GE-Hitachi Nuclear Energy Americas LLC

MFN 06-218, Supplement 1

Subject: **Response to Portion of NRC Request for Additional Information Letter No. 35 Related to ESBWR Design Certification Application – Radioactive Waste Management Systems – RAI Number 11.4-6 S01**

RAI Number 11.4-6 S01 Items a through c

Table 11.4-2
Annual Shipped Waste Volumes*

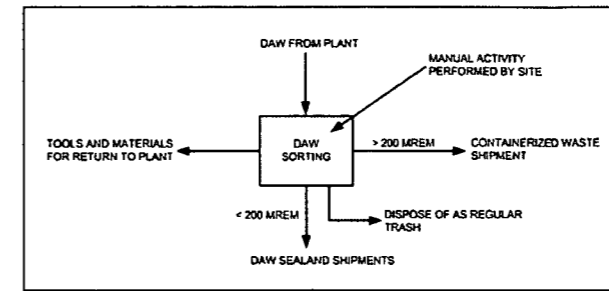
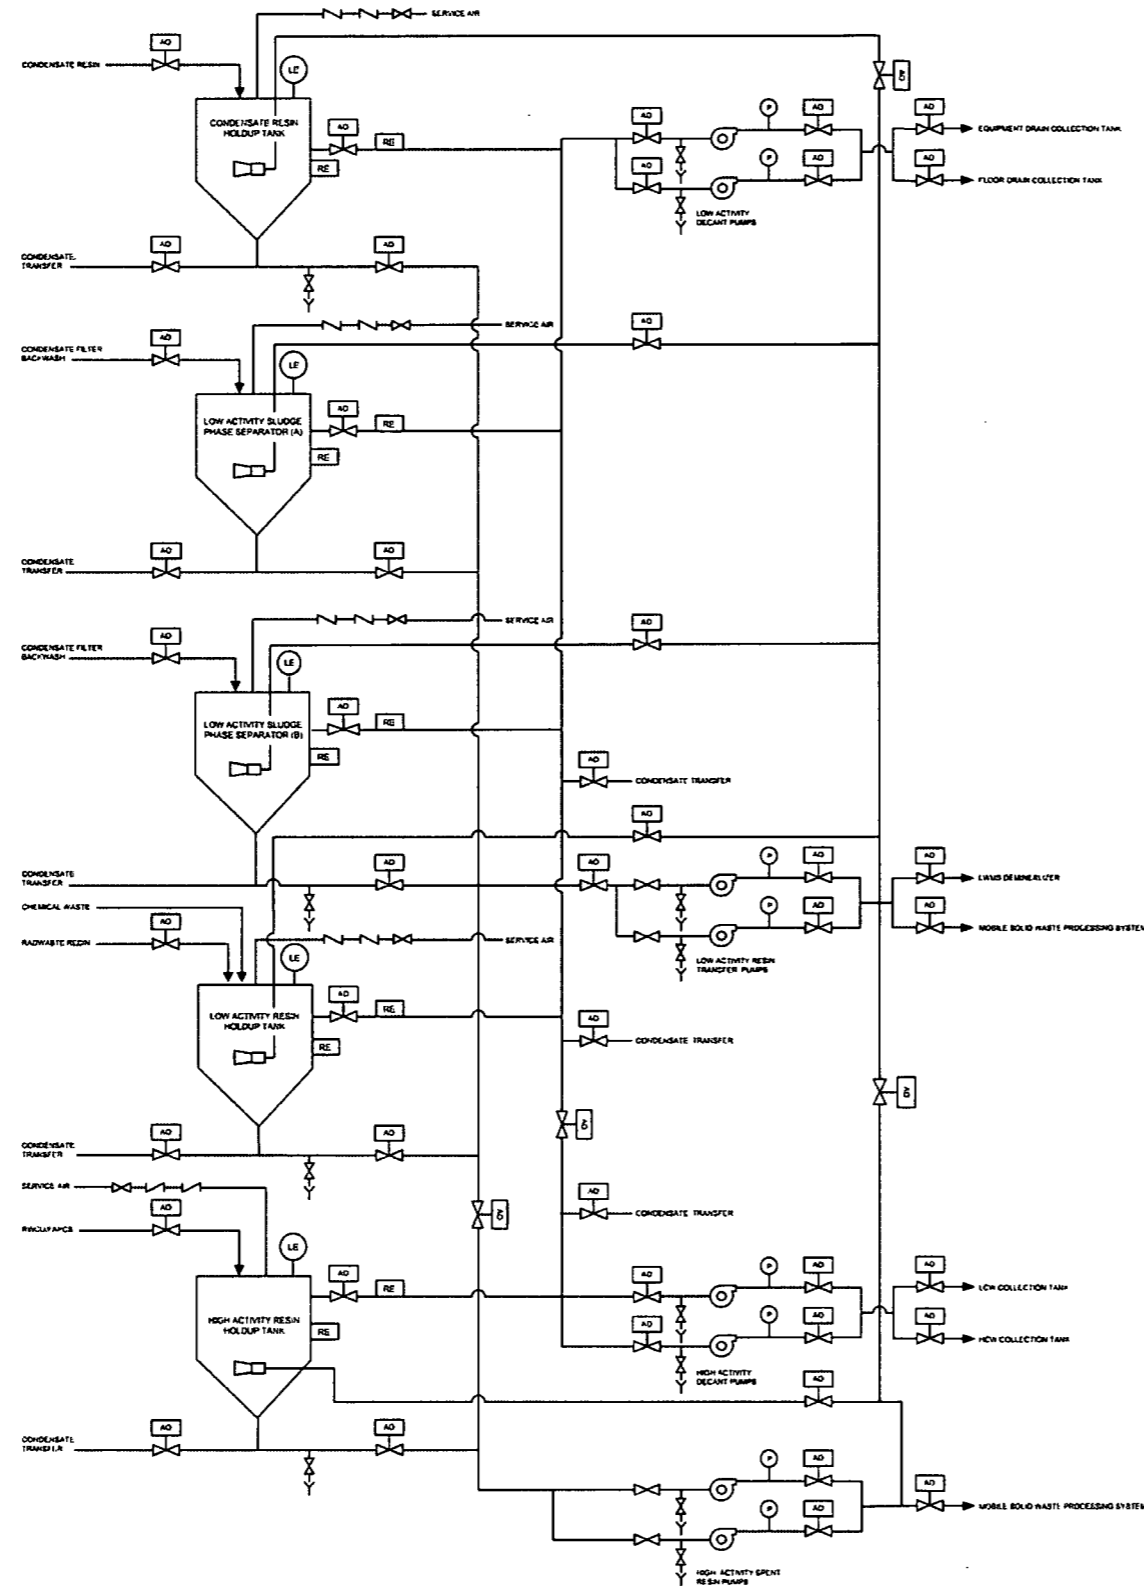
RAI 11.4-6b - A review of the estimated radwaste inventories listed in DCD Rev. 3, Table 11.4-2 indicates that the amount listed for the Wet Solid Waste Total is inconsistent with each of the listed waste streams comprising this total. Accordingly, update the value of the total waste estimate.

RAI 11.4-6c - A review of DCD Rev. 3, Table 11.4-2 indicates that the last footnote refers to the use of evaporation as a mean of achieving waste volume reduction for concentrated wet wastes. However, the use of evaporators is not discussed in DCD Rev. 3, Section 11.4.2. Accordingly, revise the footnote to eliminate evaporation as a waste reduction method or add the use of this type of waste processing technology to DCD Section 11.4.2 and update the associated DCD tables and Figure 11.4-1.

The HIC return pump (dewatering pump) will be added to Figure 11.4-3. Sorting is a manual activity performed by station personnel and will be shown on Figure 11.4-2. The wet solid waste totals have been updated on Table 11.2-4. The last footnote on Table 11.4-2 has been changed from evaporation to drying, which is discussed Subsection 11.4.2.2 for the description of mobile waste solid waste processing.

- * ~~Should a COL holder compact~~ If waste is compacted using a third party service, the estimated annual shipped waste volume provided in Table 11.4-2 ~~reduction may be reduced~~ will be considered depending on the type and level of waste and the waste compacting equipment and resulting compaction performance.
- * Note the goal value is a long term average of resins and sludges in the dewatered condition and all other wastes packaged for shipment. The values for resins and sludges in the above table are volumes packaged for shipment.
- ◊ The volume reduction is based on LWMS Concentrated Waste moisture removal. An estimate of 50% volume reduction is thought to be conservative based on current moisture removal technologies, such as ~~evaporation as drying~~ and membrane-based operations.

Figure 11.4-2. SWMS Spent Resin Sludge Transfer System
*Conceptual Design

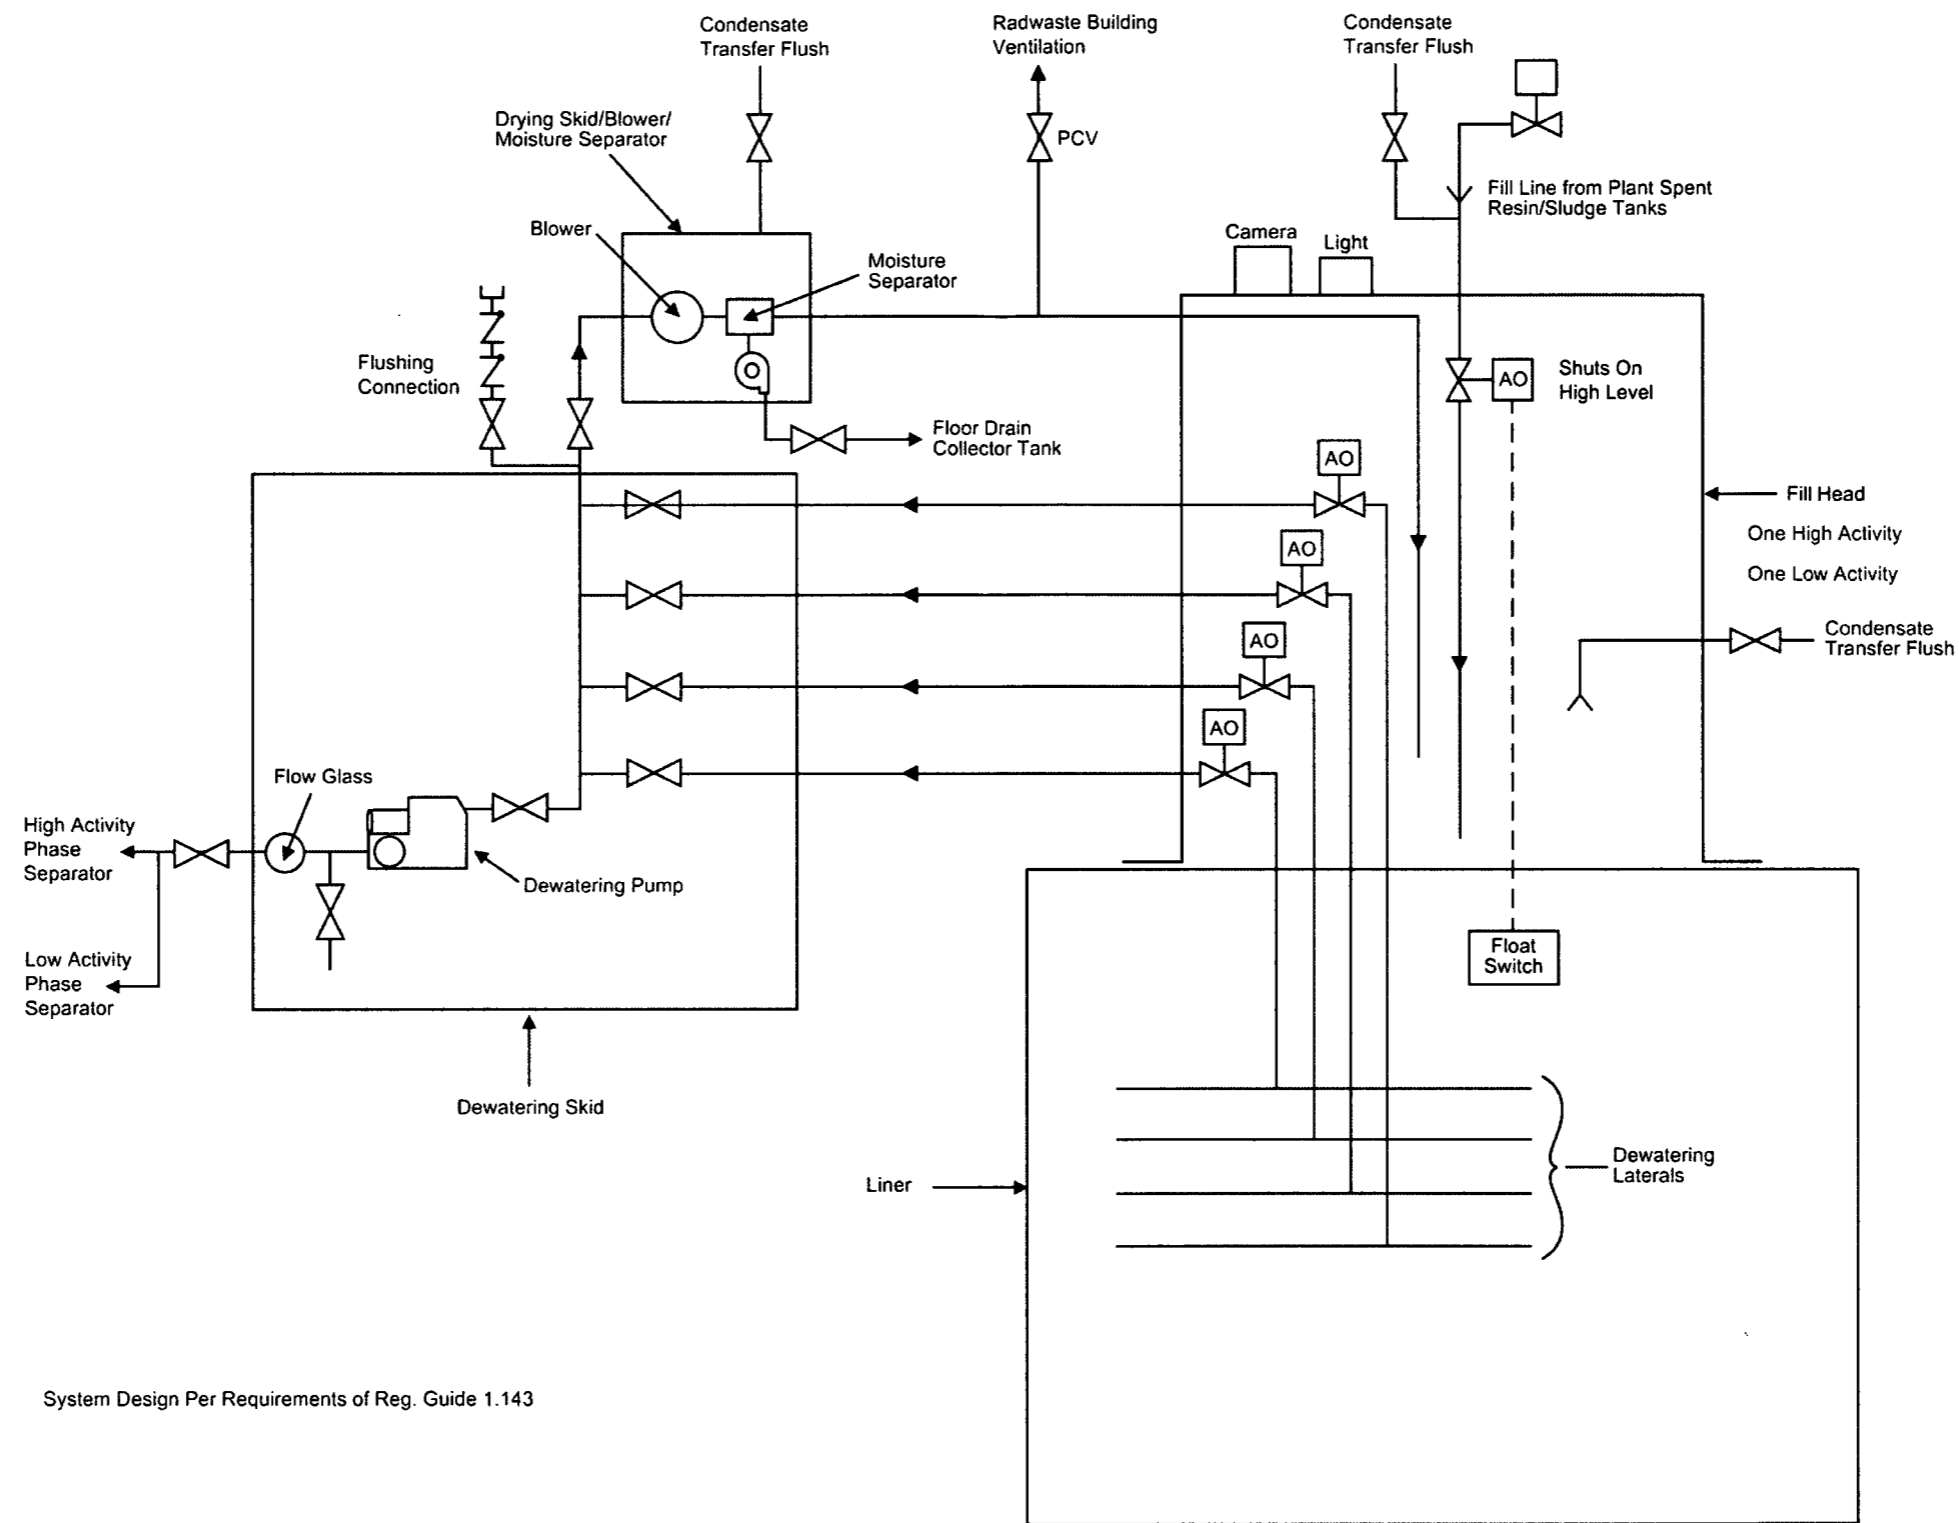
RAI 11.4-6a - A review of the system components listed in DCD Rev. 3, Table 11.4-1 and Figure 11.4-1 indicates that the HIC Return Pumps and Sorting Table are not shown in Figure 11.4-1. Accordingly, update the table and figure to indicate where in the SWMS these components are located.
